**Indiana State University Federal Credit Union – Addition: A20-016**

September 7, 2021

**Addendum #1**

**A4.0**

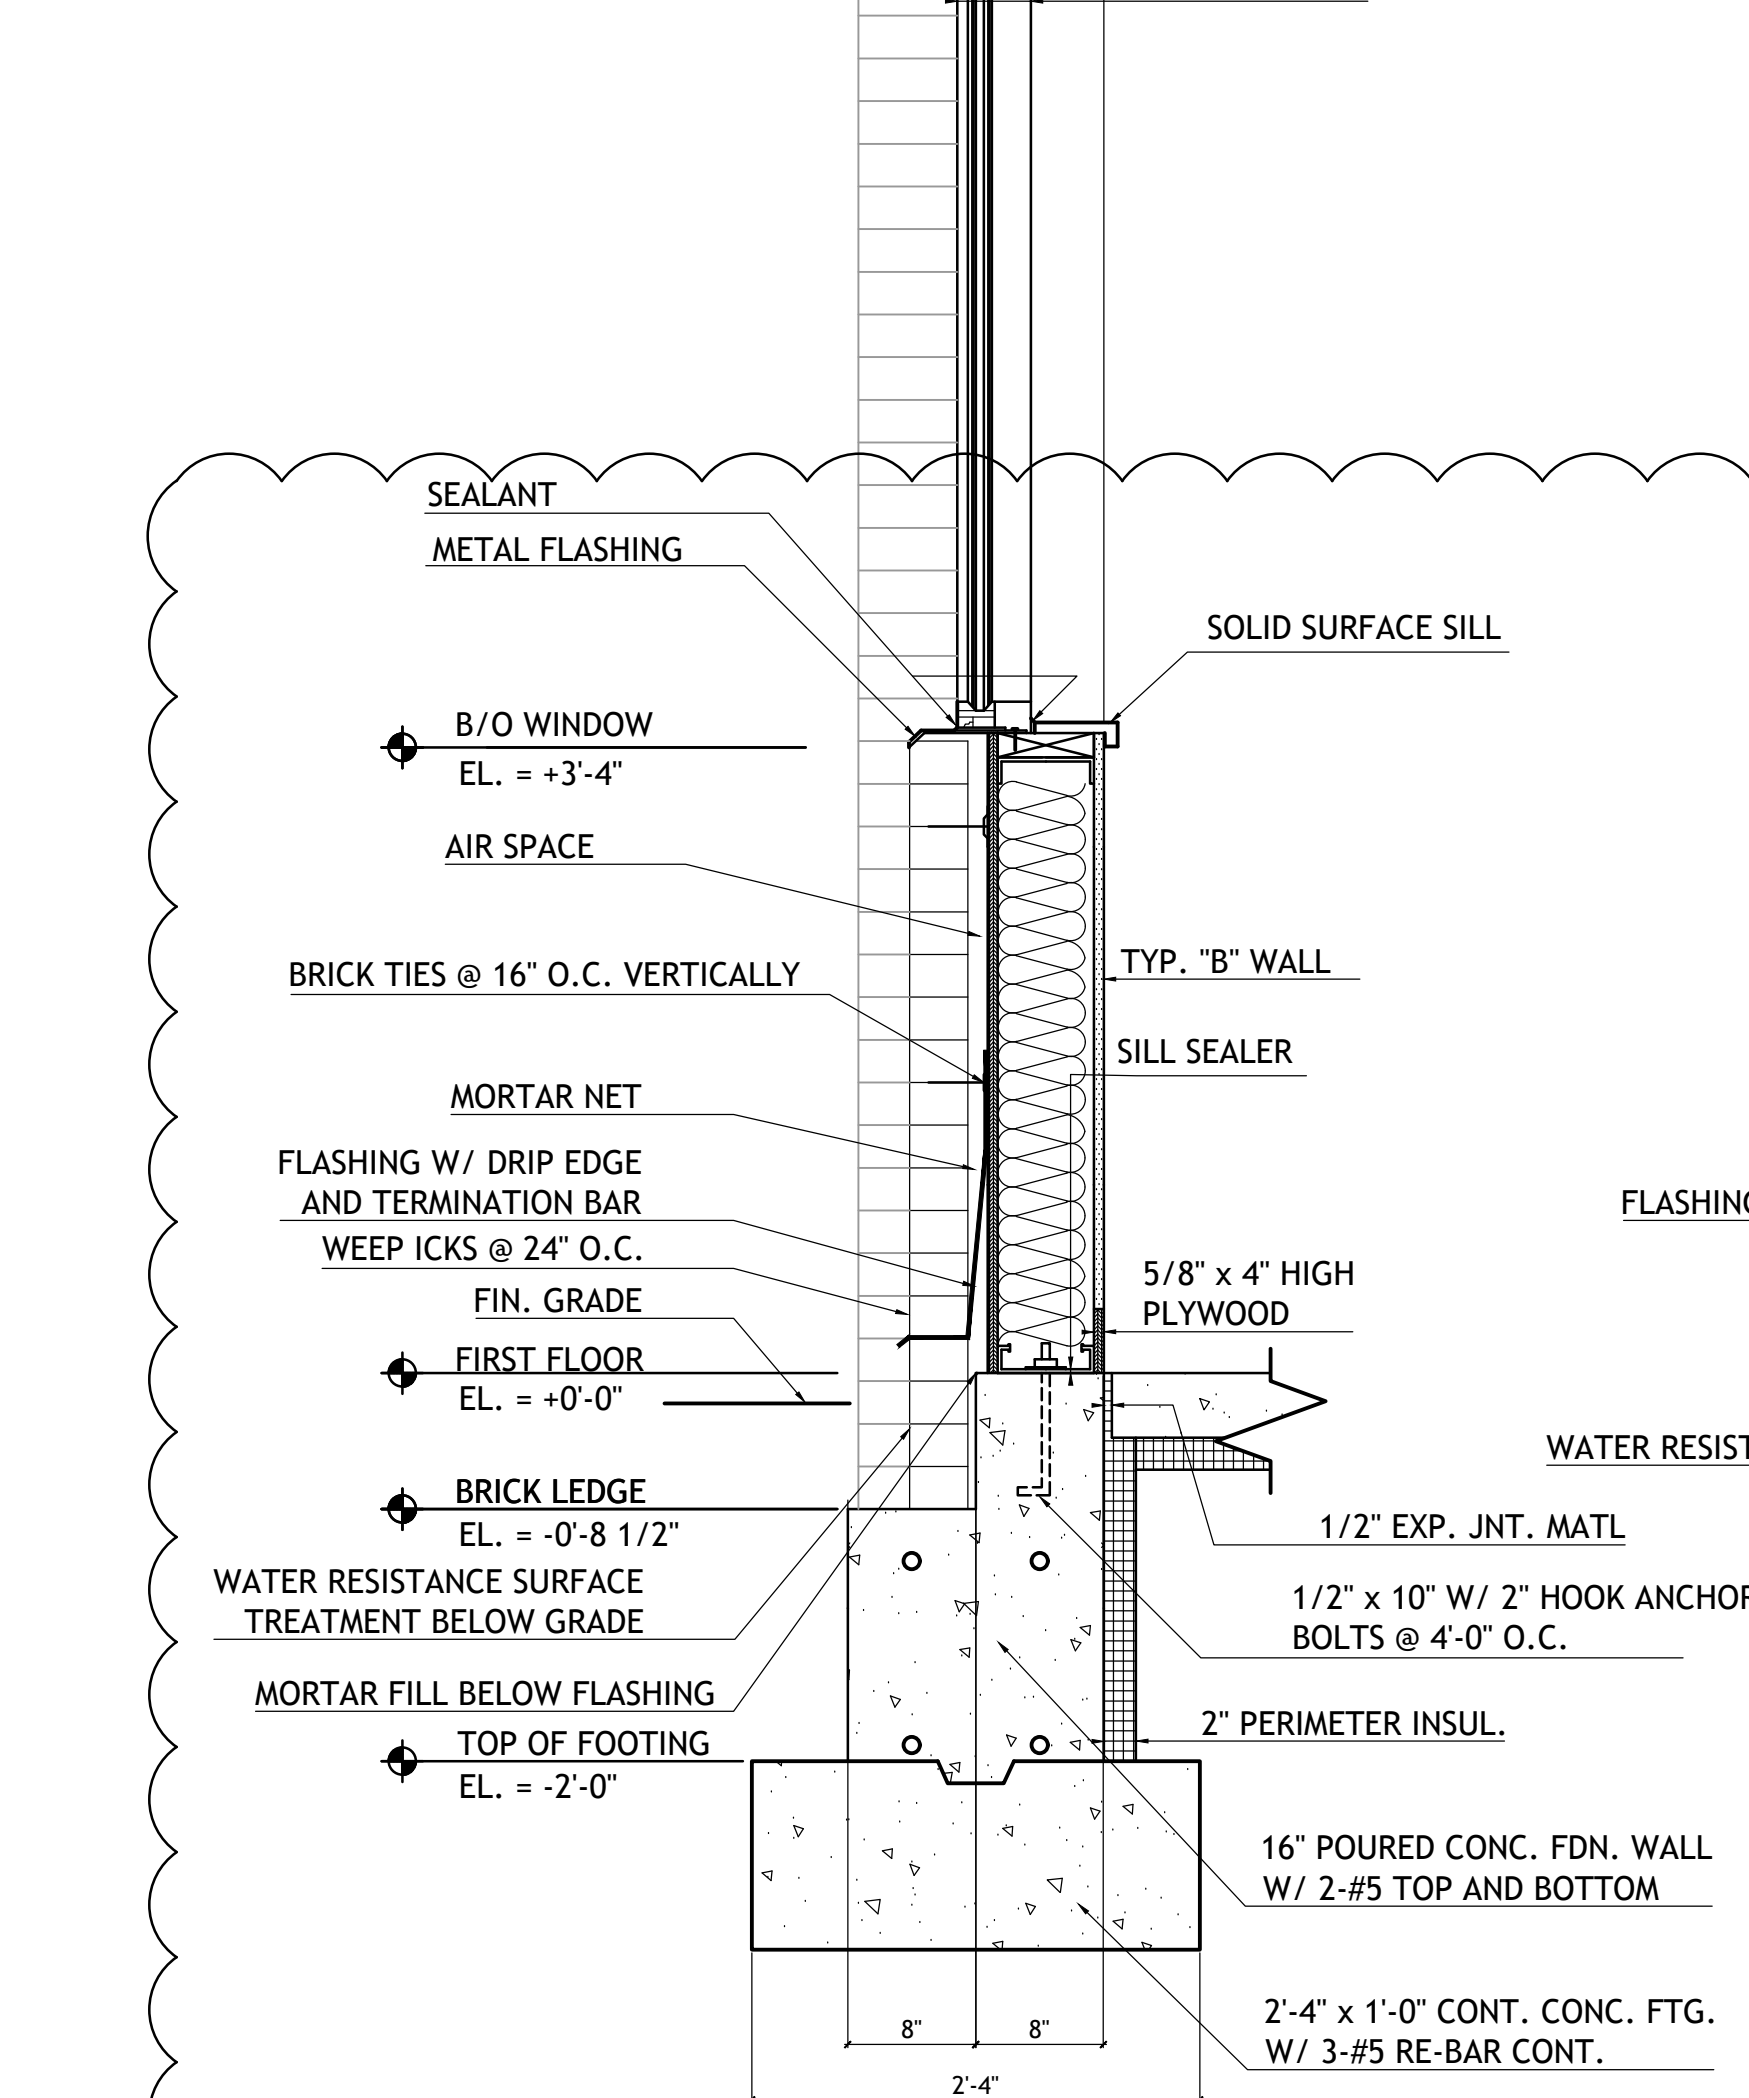
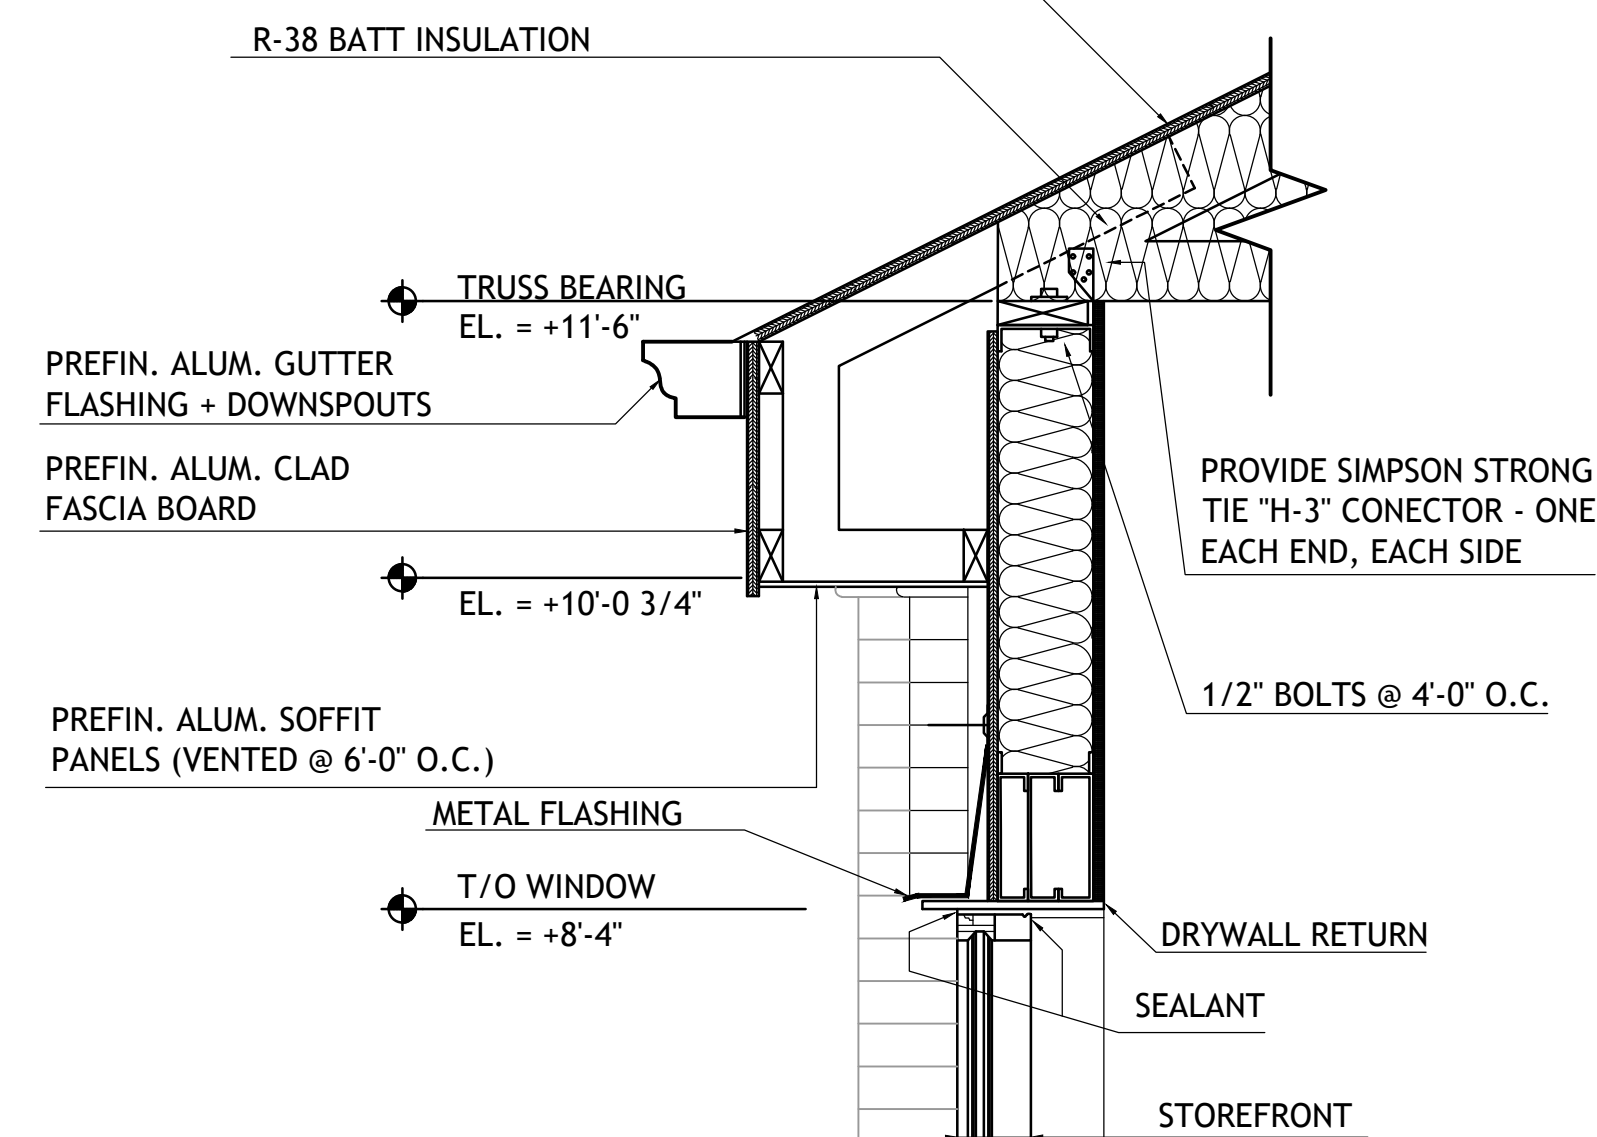
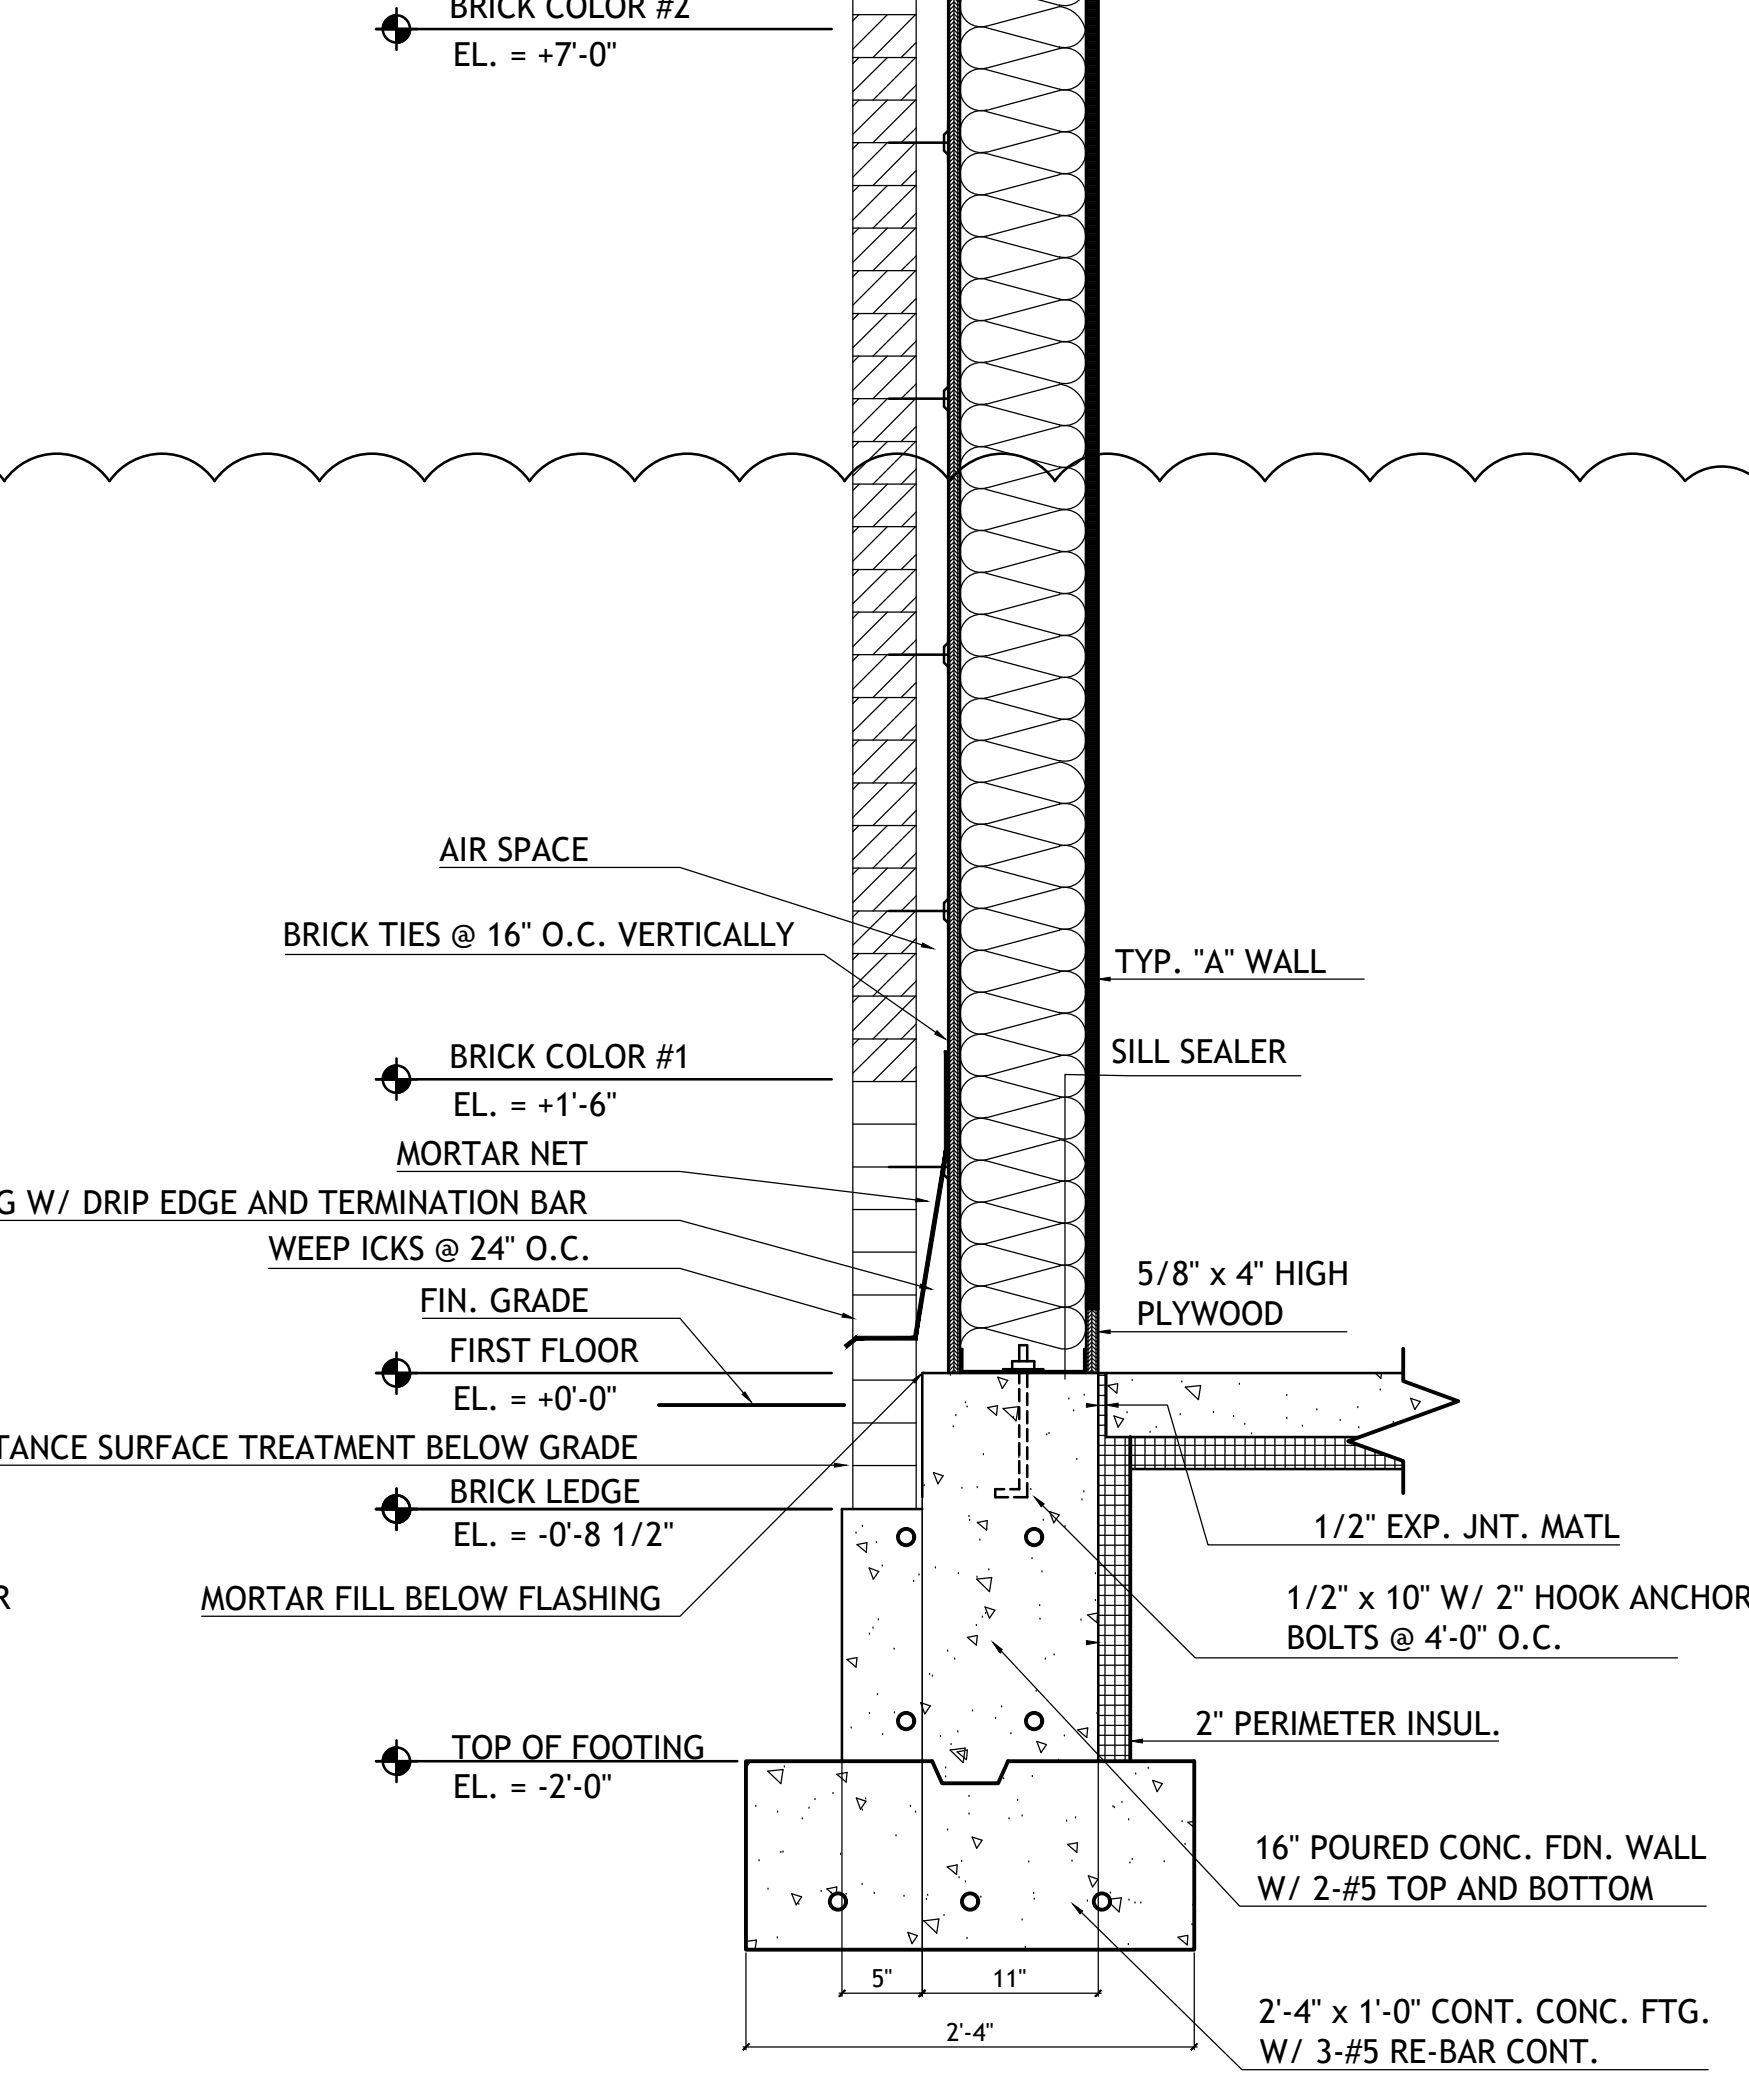
1. Replace sheet with attached sheet affixed with revision note '1 – Addendum 1 – 09.07.2021'
2. Sections revised
